# Work Order ID 71376

Item Name: Crosstube Aft

DRAWING NO. D412-664-243	TITLE CROSSTUBE ASSEMBLY (412 HI AFT)	REV. E	DART AEROSPACE LTD ENGINEERING ORDER		D.E.O. NO. D412-664-243-E-1	SHEET NO. SHEET 1 OF 2	SCALE NTS
DRAWN	CHECKED <i>MP</i>	MFG. APPR. <i>E</i>	APPROVED <i>MP</i>	DE APPR. <i>MP</i>			
DATE 11.03.31	DATE 11/03/31	DATE 11.03.31	DATE 11/03/31	DATE 11.03.31

DRAWING NO. D412-664-243	TITLE CROSSTUBE ASS'Y (412 HI AFT)	REV. E	DART AEROSPACE LTD ENGINEERING ORDER		D.E.O. NO. D412-664-243-E-2	SHEET NO. SHEET 1 OF 1	SCALE NTS
DRAWN. <i>qp</i>	CHECKED <i>ASS</i>	MFG. APPR. <i>RE</i>	APPROVED <i>MP</i>		DE APPR. <i>TH</i>		
DATE 11.09.07	DATE 11.09.19	DATE 11.09.19	DATE 11.09.19		DATE 11.09.19

**D212-664-243**  
**ASSEMBLY DETAIL**

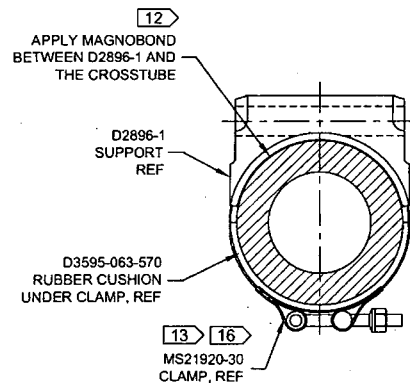
**PURPOSE:**

REMOVED ABRASION STRIP IN FAVOR OF A THIN LAYER OF PROSEAL 890.

**IS:**

D3189-1 CHAFING SHIELD (1, INSTALLED OVER PROSEAL 890)  
MS21920-28 CLAMP, 2X  
2 PL

**WAS:**

D2856-600-1009 ABRASION STRIP  
D3189-1 CHAFING SHIELD (1, INSTALLED OVER ABRASION STRIP)  
MS21920-28 CLAMP, 2X  
2 PL

**D412-664-243  
ASSEMBLY DETAIL**

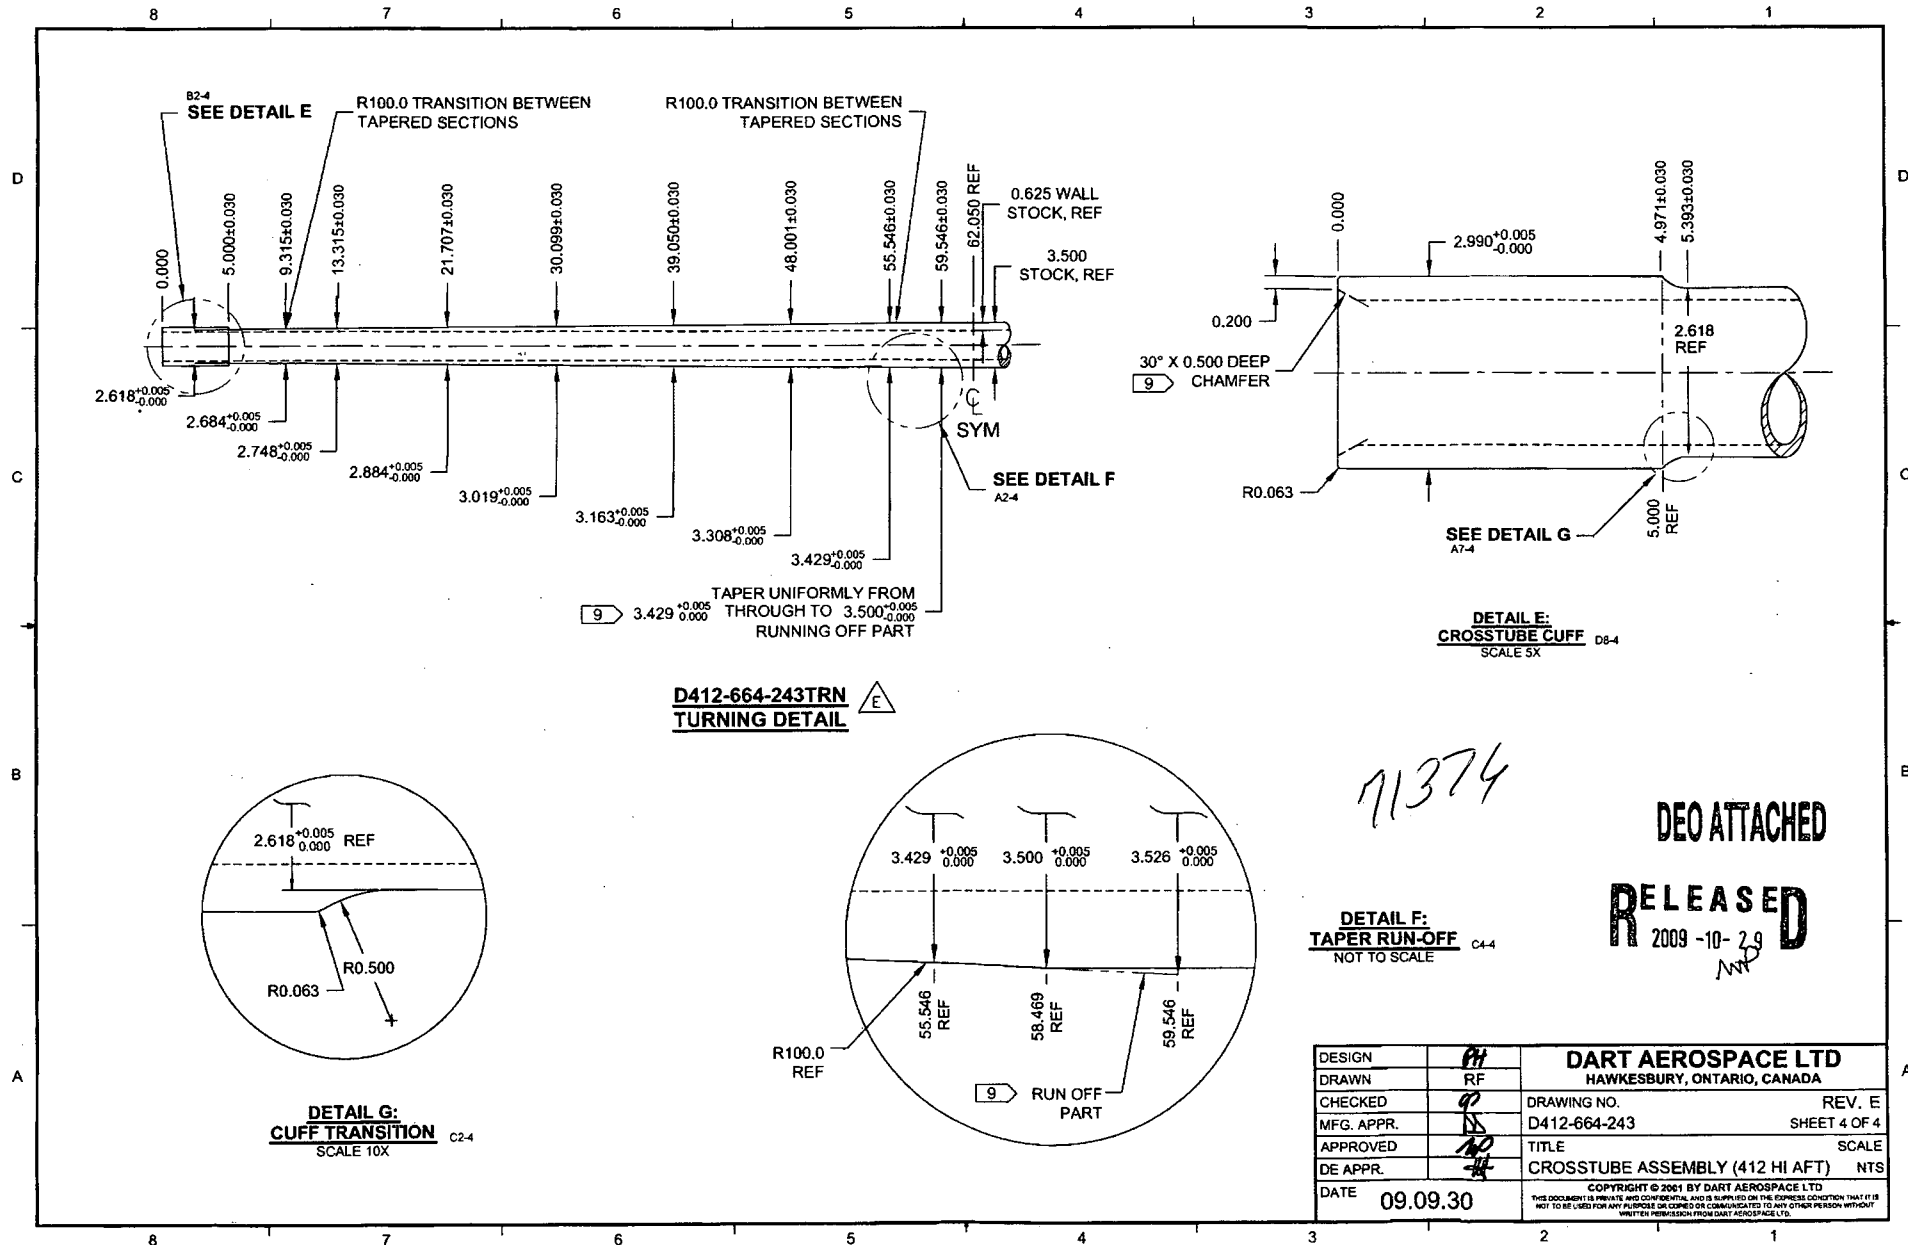
MASK AREA PRIOR TO PAINTING AND  
APPLY CLEAR COAT AFTER PAINTING
